ROOSEVELT

ROOSEVELT REVISION LIST - STRUCTURAL:

ROOSEVELT REVISION LIST - ARCHITECTURAL:

DATE: APRIL 26, 2017 REV.: MAY 01, 2020

SLAB INTERFACE PLAN A-4

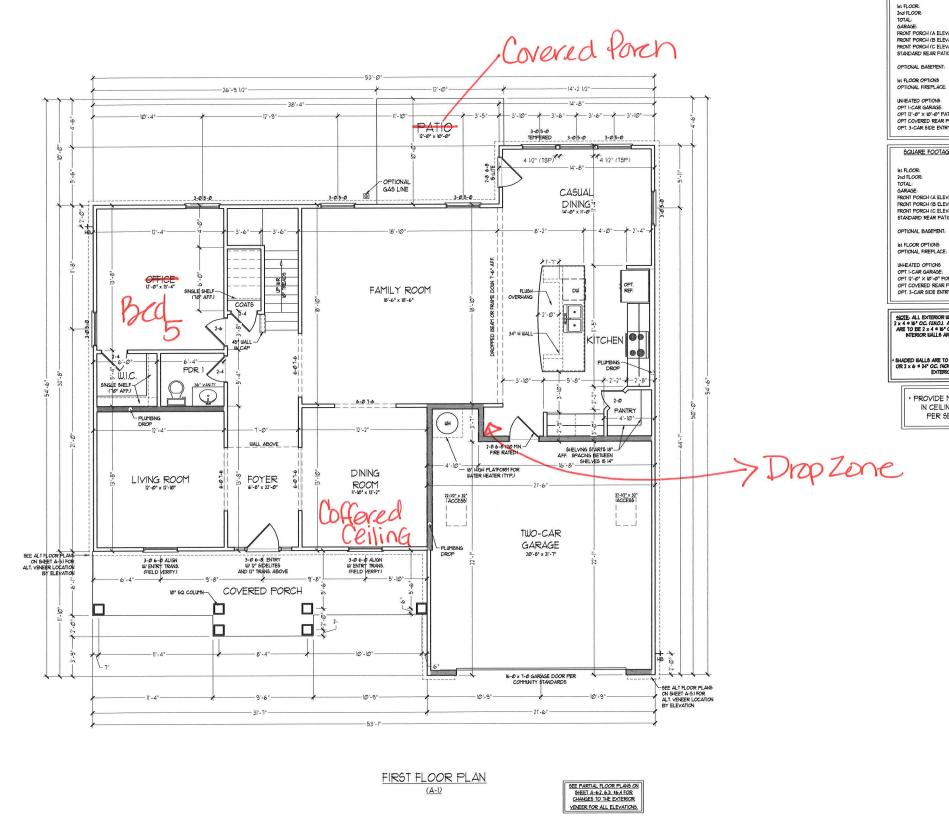
- 15. ADDED DIAGONAL DIMENSIONS TO SLAB INTERFACE PLAN (05-01-20)
- 16. ADDED OPTIONAL FLOOR OUTLETS TO SLAB INTERFACE PLAN (05-01-20)

WALL SECTIONS AND STAIR DETAIL

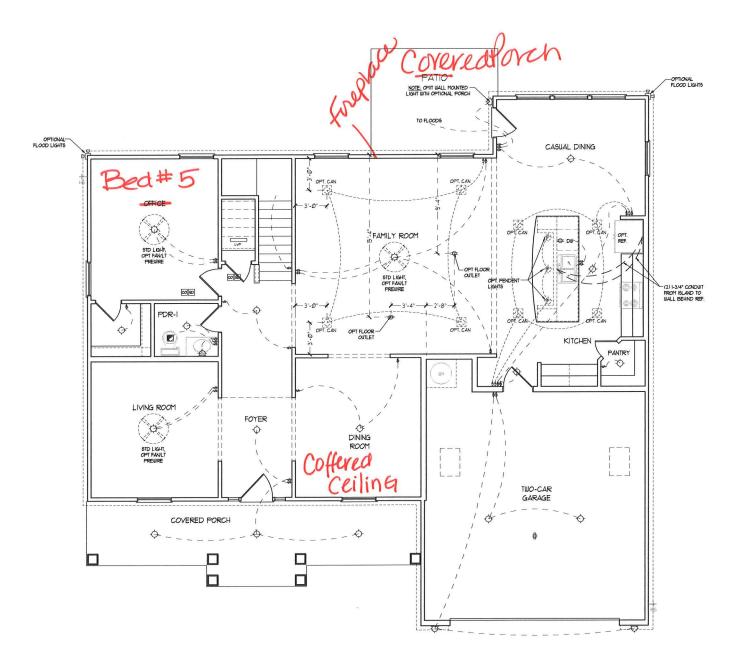
- 28. REMOVED ALL CASED OPENINGS (C.O.) FROM PLAN (05-01-20)
- 29. UPDATED COLUMNS ON COVERED REAR PORCH TO 8x8 COLUMNS (05-01-20)
- 30. ADDED SHEET AD-1 WALL SECTIONS AND STAIR DETAIL (05-01-20)
